Re: **Immediate Response Action Plan (IRAP)**
GE Pittsfield Unkamet Brook, DEP SA 1-0148
Release Tracking Number 1-10380

**IMMEDIATE RESPONSE ACTION (IRA)
TRANSMITTAL FORM** Pursuant to 310 CMR 40.0424 - 40.0427 (Subpart D)

Re: DEP: 1-0148 Pittsfield; EPA: Area 1;
GE/Unkamet Brook; Phase II/RFI Proposal
comments and requirements for resubmittal,
schedule, and conditional PHEAP approval

**Re: IRA Plan
RTN 1-10380
SA 1-0148
US EPA Area 1
GE Pittsfield**

Figure 2B

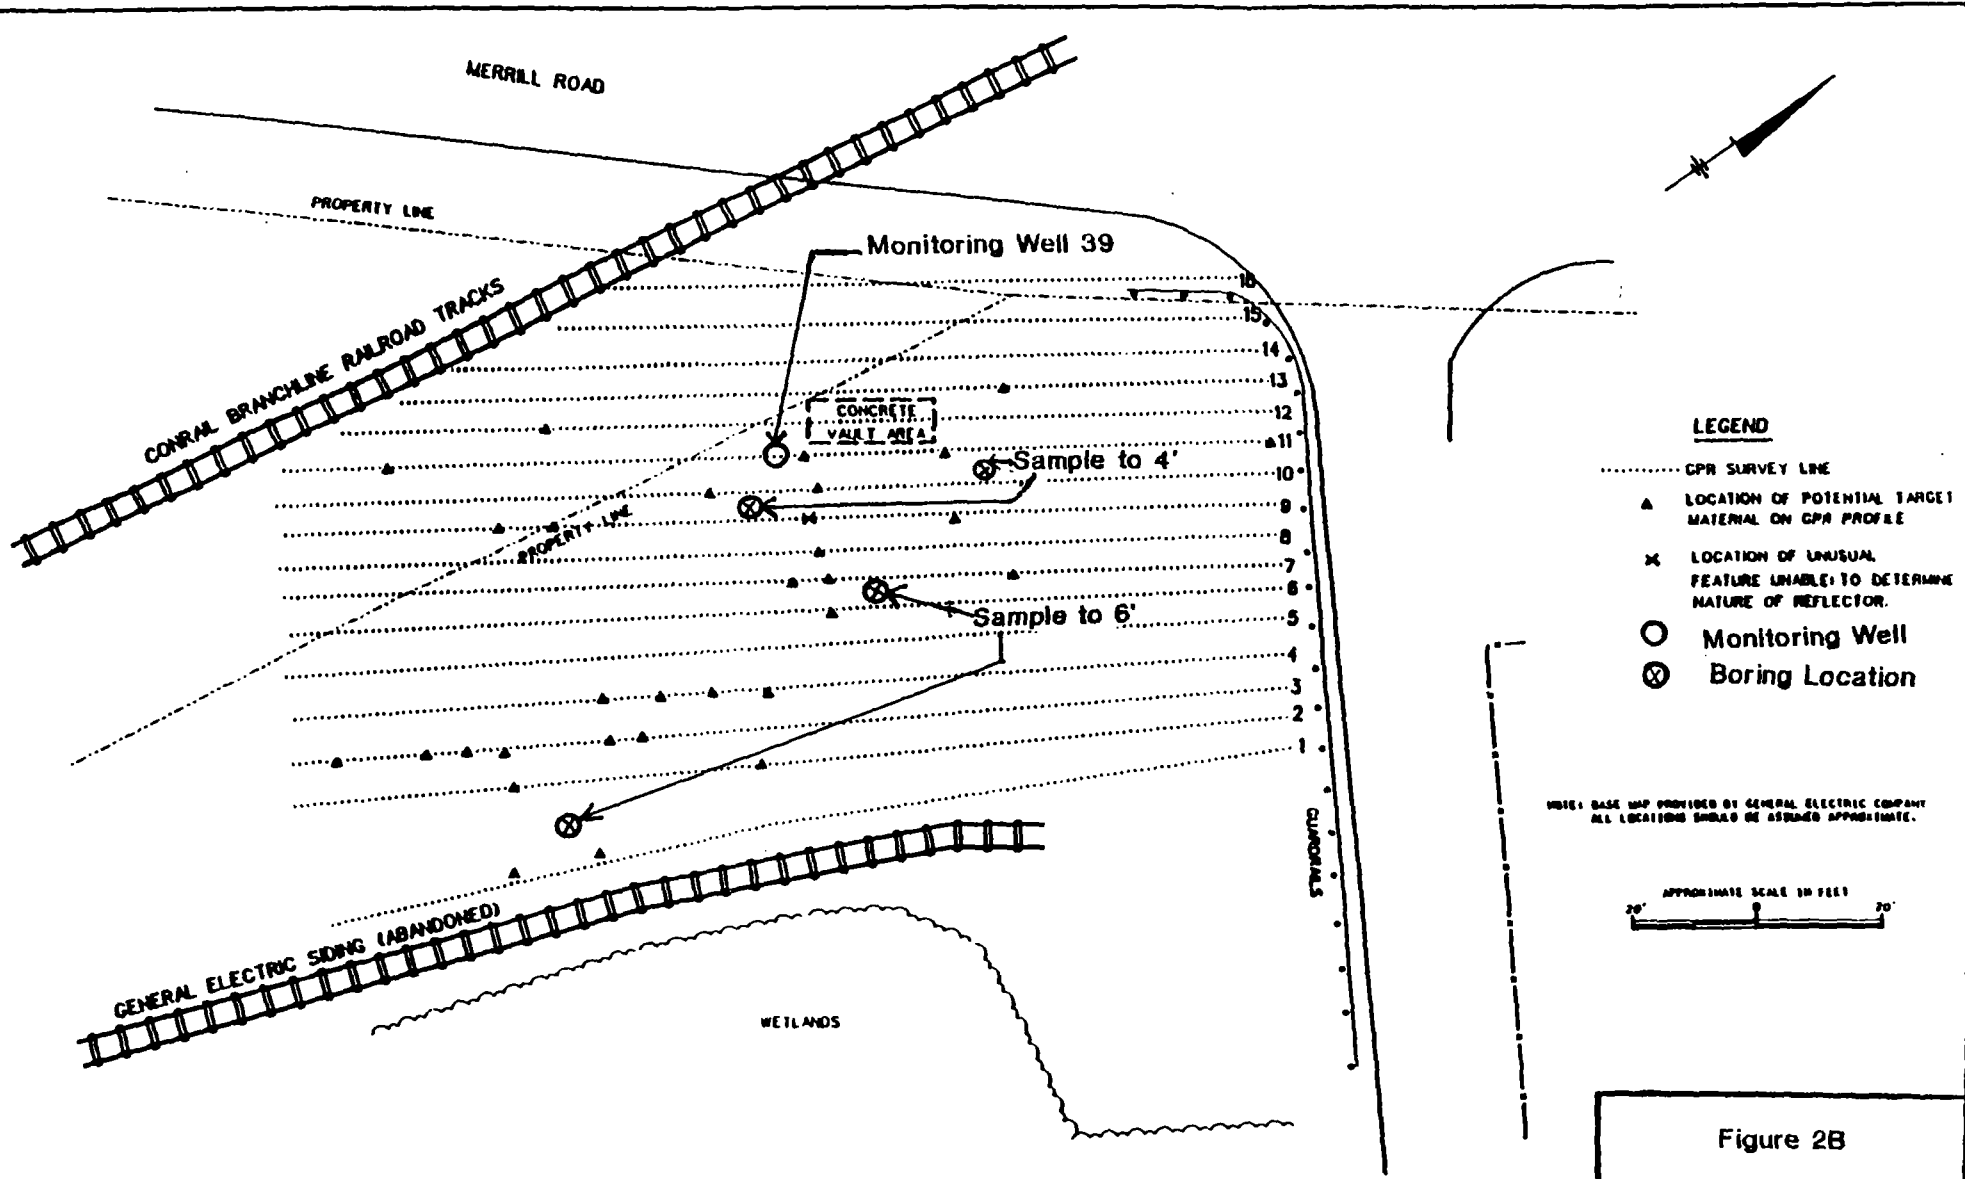
In November 1994, GE's contractor, Blasland & Bouck, completed a ground penetrating radar survey of the area. A summary of their report (Figure 2B) is attached. It shows 30 "potential" targets and one "unusual feature." The work plan covers the steps to be taken to investigate each of these anomalies.

Permission from Conrail will be required to investigate the three targets shown within 30' of the Conrail branch line railroad tracks (southernmost targets on lines 9, 11, and 12). It is GE's intent to have the necessary permits and permissions in place so the work can be accomplished before ground freeze up in mid-November 1995. Based on prior experience, Conrail approval may not be received within that time frame and, if such is the case, GE will move ahead on all save those targets.

wells were selected. As previously discussed, MW 39 was installed and tested during the steam line installation and is located within the area of investigation. To determine groundwater conditions downgradient from the area of investigation, a piezometer well will be installed (Figure 2B). In addition, MW 39 will be sampled to determine if groundwater conditions have changed since the analytical results reported to MDEP on March 11, 1994. A groundwater sample collected in the piezometer well and MW 39 will be analyzed for the same constituents measured in 1994 (VOC, SVOC, metals, PCB, and pesticides). Prior to sample collection MW 39 will be redeveloped.

FIGURE 1-2

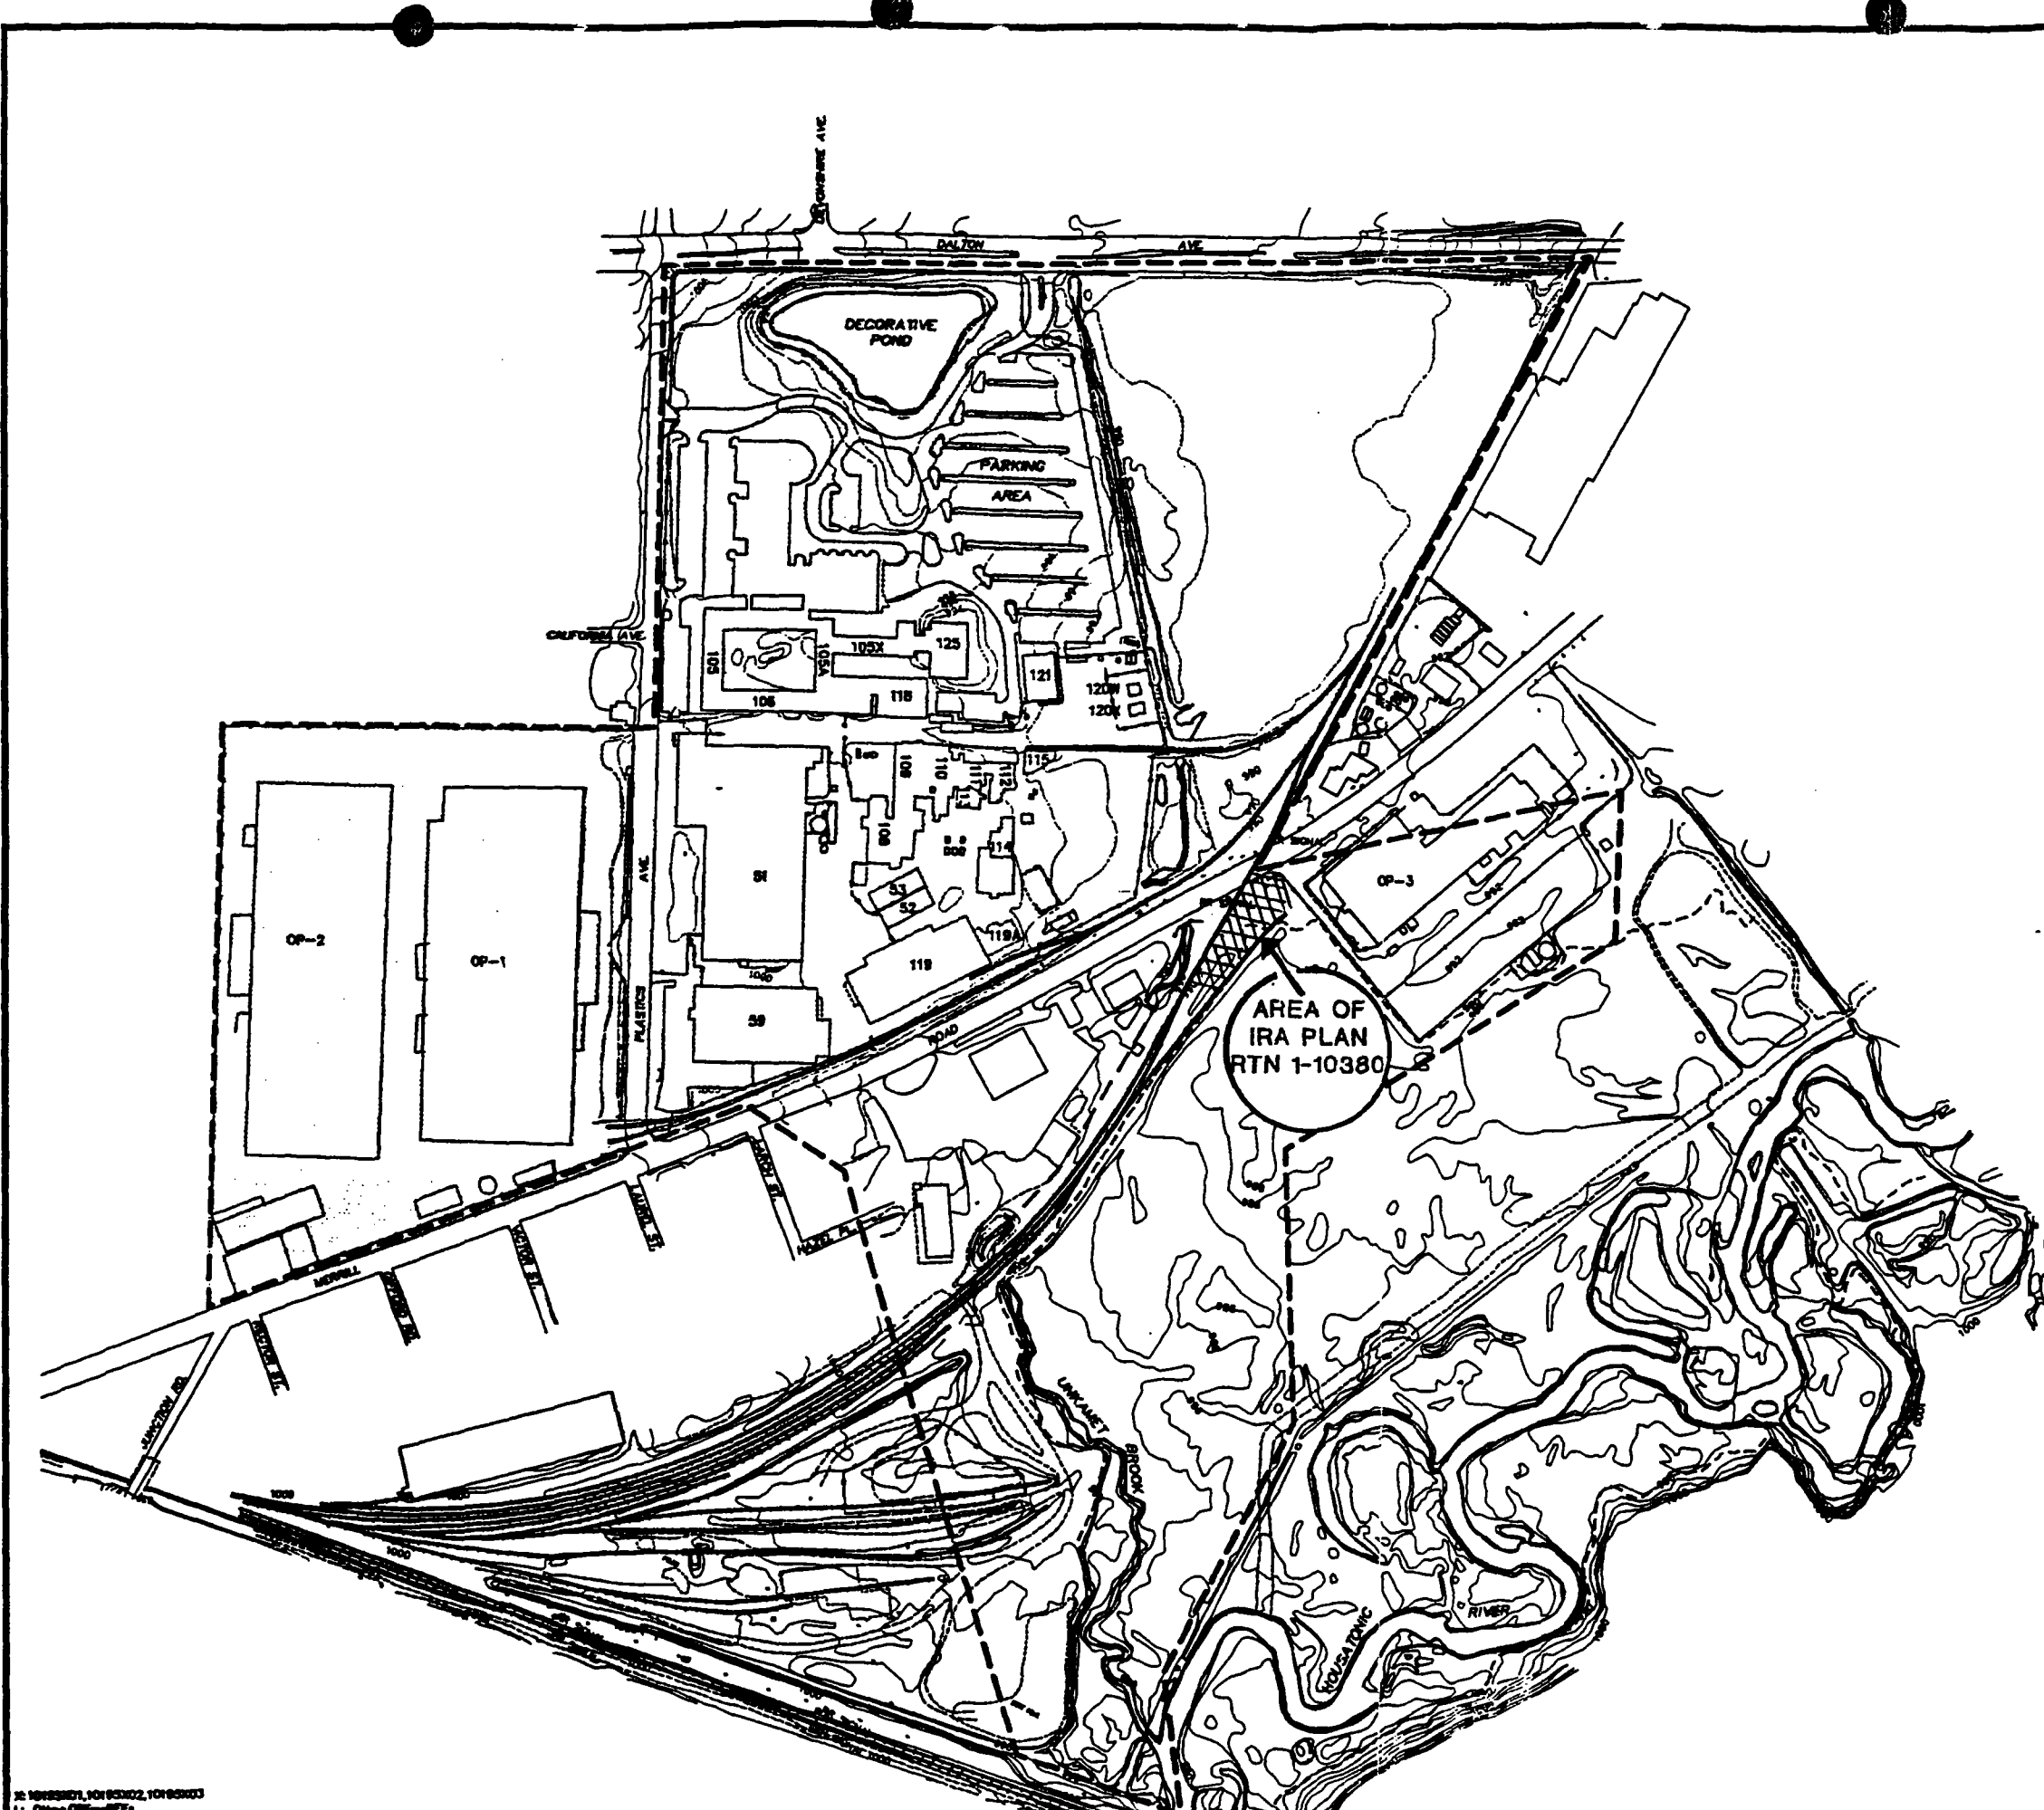
The site of the proposed work is within the 100-year floodplain under an area of maintained (periodically mowed) grass. A triangular shaped piece of approximately 1/4 acre is shown on a marked-up copy of Figure 1-2 from the January 1995 "MCP Interim Phase II Report and Current Assessment Summary for Unkamet Brook Area/USEPA Area 1." Figure 2-4 from the same report is a 1990 aerial photograph showing the surrounding receptors. Less than 100 feet north is Merrill Road and immediately across the road is Unkamet Brook and associated wetlands. To the east is Lockheed Martin's (formerly operated by GE) building OP3. A driveway to the little-used paved parking area at the rear of OP3 is bordered by a fence preventing access to the building. West of the site is Unkamet Brook with a commercial office building (presently unoccupied) on the far side.
